# Chapter 11 Addendum: Offshore Ornithology

## ORIEL WIND FARM PROJECT

**Environmental Impact Assessment Report - Addendum  
Chapter 11 Addendum: Offshore Ornithology**

MDR1520C  
EIAR –  
Chapter 11 Addendum  
A1 C01  
December 2025

**Figure 11A-1: The ObSERVE collection areas and aerial transect lines flown in the summer of 2021 and 2022 and winter of 2022/23. The western Irish Sea is the area covered by Stratum 5.**

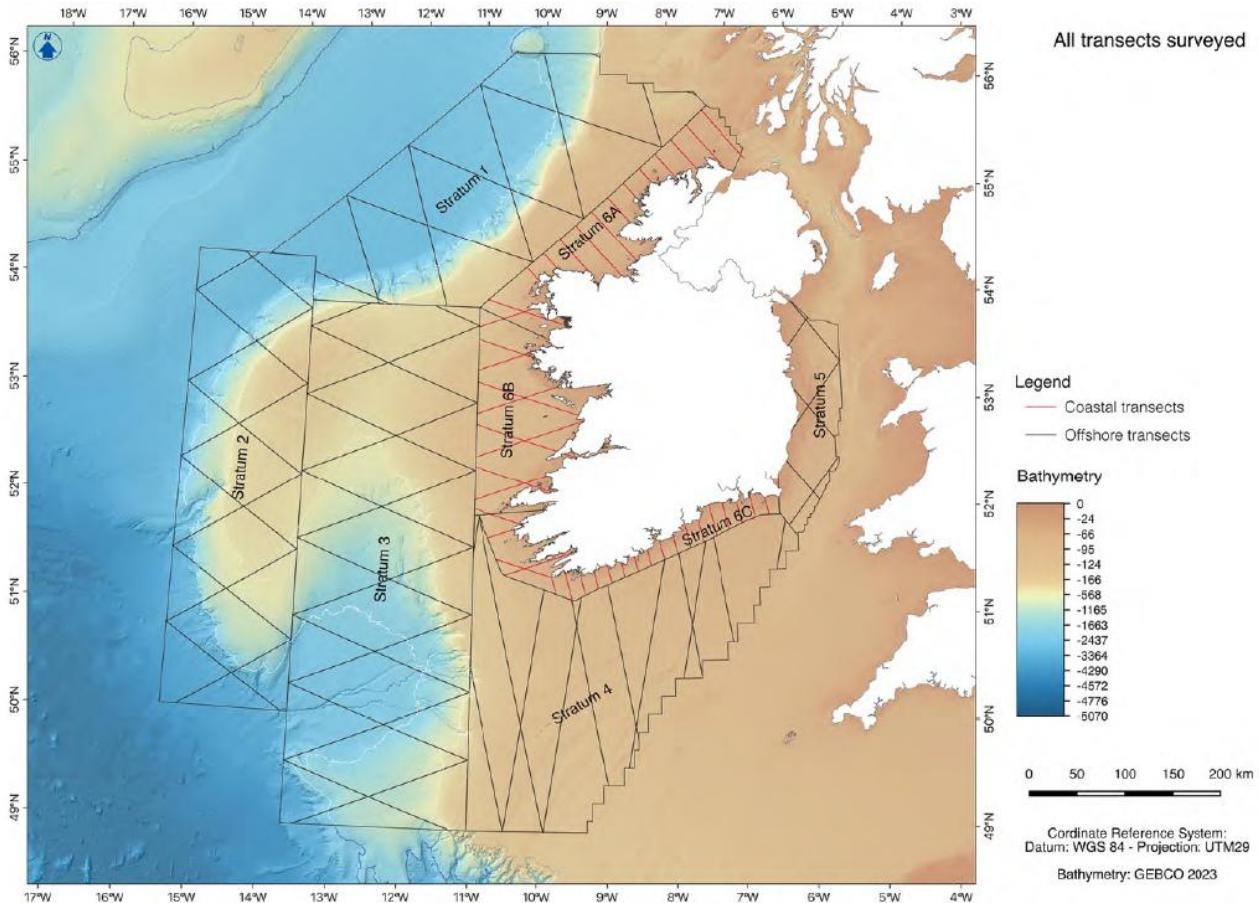
This approach addresses the Board's concerns: it specifically responds to gannet-related issues (comment 7K) and to the broader concerns for all species (comment 7P) by using ObSERVE's survey-derived, model-based estimates for Stratum 5 to calculate the project-alone predicted increase in baseline mortality, using the western Irish Sea population as a reference.

The modelled estimates for Stratum 5 therefore provide a regional population context for assessing the project-alone impact. Table 11A-17 presents the Stratum 5 estimates for the western Irish Sea population and the corresponding increase in baseline mortality attributable to the project alone.

While ObSERVE provides useful survey-derived, model-based estimates, those outputs are not adequate as the sole basis for regional impact assessment for the following reasons:
